Re: MM Docket No. 93-37  
 FCC File BPED-900905MI

**HEARING DESIGNATION ORDER**

PETITION FOR LEAVE TO AMEND

**BEACON BROADCASTING CORPORATION  
APPLICATION BPED-900905ML FOR A NEW NCE-FM STATION  
ALLENTOWN, PENNSYLVANIA**

RADIOFREQUENCY RADIATION STUDY

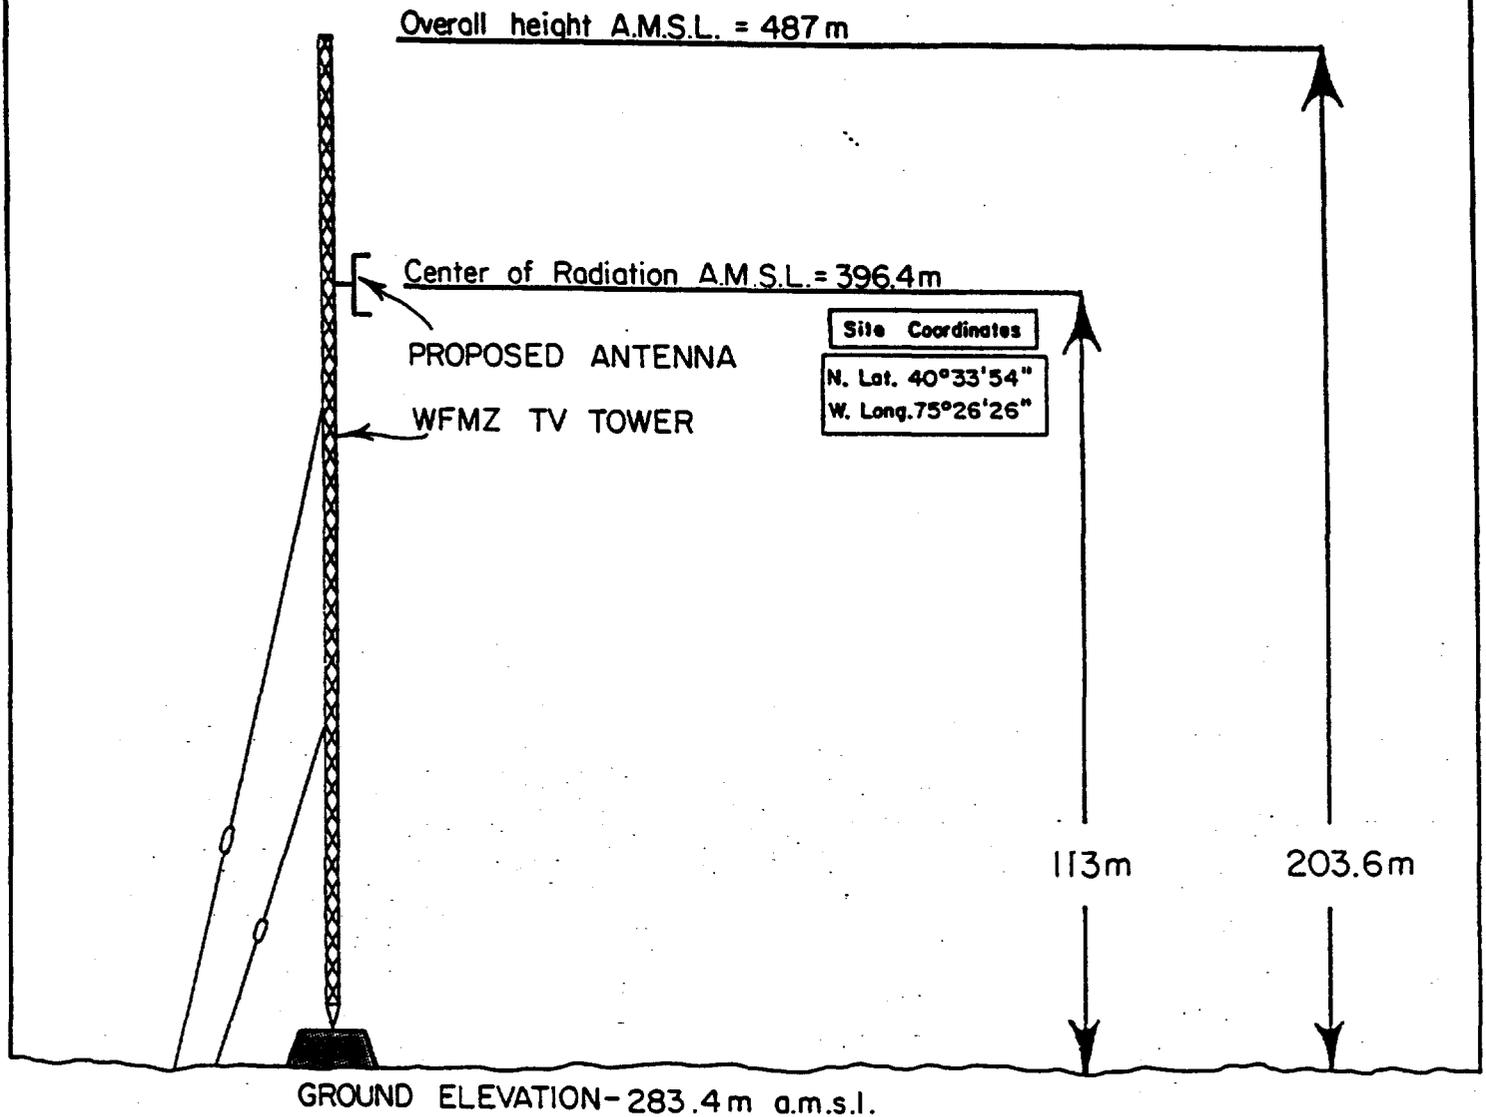
3. Paragraph 17 in the HDO indicates that Beacon has failed to address the matter of how it proposes to resolve any RF exposure to workers on its proposed tower. As the attached engineering amendment indicates, Beacon did in fact address this matter in its application. It is believed by Beacon that its original showing in this regard fully complies with the Commission's policy for resolving RF exposure to workers on the tower.

COMPLIED WITH PARAGRAPH 17, HDO

The following calculations are performed in order to determine, whether the proposed FM station has a significant environmental effect. The calculations to determine power densities ( $\text{mW}/\text{cm}^2$ ) and power density levels of all TV and FM facilities are computed by using the following equation:

$$\text{Power density in } \text{mW}/\text{cm}^2 \text{ (S)} = \frac{(33.4)(F^2)[(.4)(\text{Visual ERP}) + \text{Aural ERP}]}{(\text{Distance from Center of Radiation})^2}$$

In the above equation, ERP is the total power of horizontal and vertical polarization in kilowatts, distance to a location is in meters and F is the relative field strength towards the location from the vertical plane pattern. For the proposed FM facility, the total ERP is 0.125 kW and the center of radiation is 113 meters above ground. At a depression angle of 90 degrees F is assumed to be 1.0, that is the "worst case" assumption. Therefore, maximum power density for the proposed FM facility at the base of the tower is  $0.000333 \text{ mW}/\text{cm}^2$  or 0.03 percent of the FM permitted maximum. For television station WFMZ-TV "worst case" power density near the tower base, F is 1.0 and aural power is 22 percent of visual. Therefore worst case WVTM-TV power density is  $0.92 \text{ mW}/\text{cm}^2$ . This 34.3 percent of the maximum permitted for operation on channel 69 ( $2.68 \text{ mW}/\text{cm}^2$ ). In the case of station WFMZ(FM) the calculated power density for "worst case",  $F=1$ , is  $0.065 \text{ mW}/\text{cm}^2$  or 6.5 percent of the FM maximum.

Therefore, the total calculated "worst case" power density at the base of the tower is less than 41 percent of the permitted maximum. Thus, the proposal is in compliance with OST Bulletin No. 65 and the ANSI Standards.

To assure that personnel working on the tower is not excessively exposed, the applicant will reduce power or turn the transmitter off, as necessary, to make sure that such persons will not be exposed to excessive levels of Radiofrequency Radiation.
